Product Change Notification—PCN# **PCN000988**

We would like to inform you that Moxa is going to make changes to the ioThinx 4530 Series. These changes will be implemented by April 01, 2024. Please review the details below to determine how the changes will affect your products and/or operations.

Product transition timeline

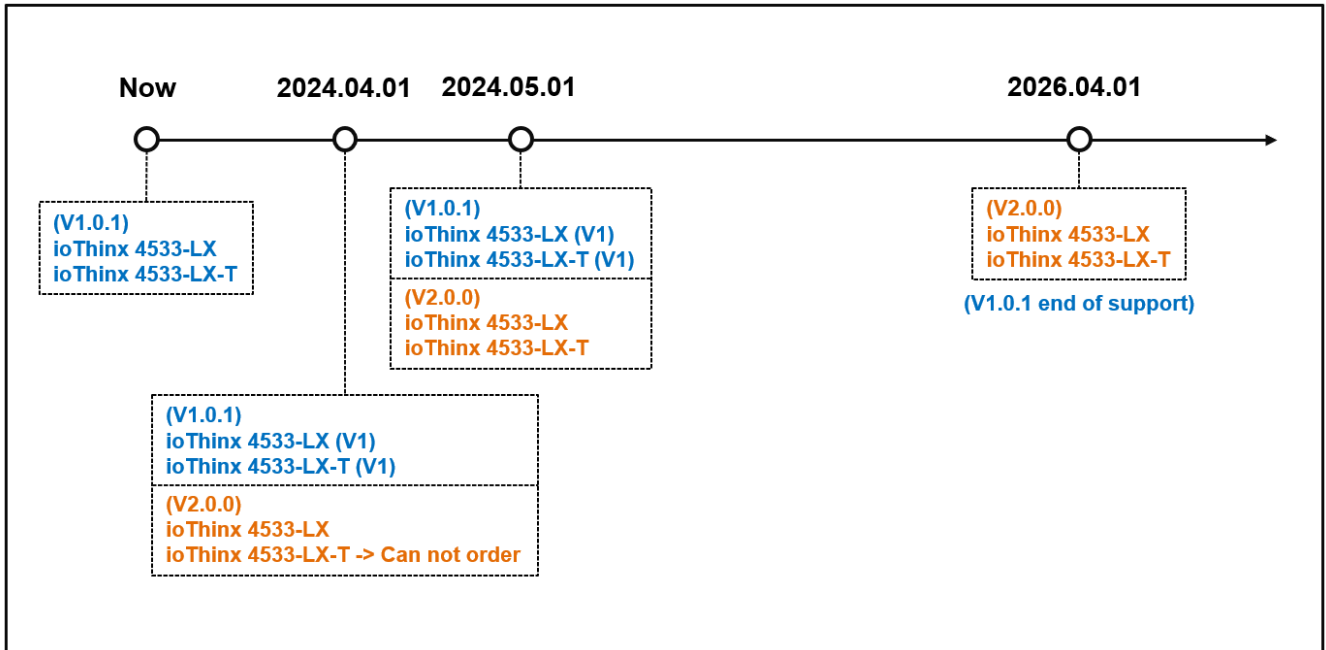
These changes will not be backward compatible. Hence, we will make **ioThinx 4533-LX (V1)** and **ioThinx 4533-LX-T (V1)** models available to continue support for your existing applications.

Product Name	Available for Order	End of Support
ioThinx 4533-LX (V1)	April 01, 2024	April 01, 2026
ioThinx 4533-LX-T (V1)	April 01, 2024	April 01, 2026
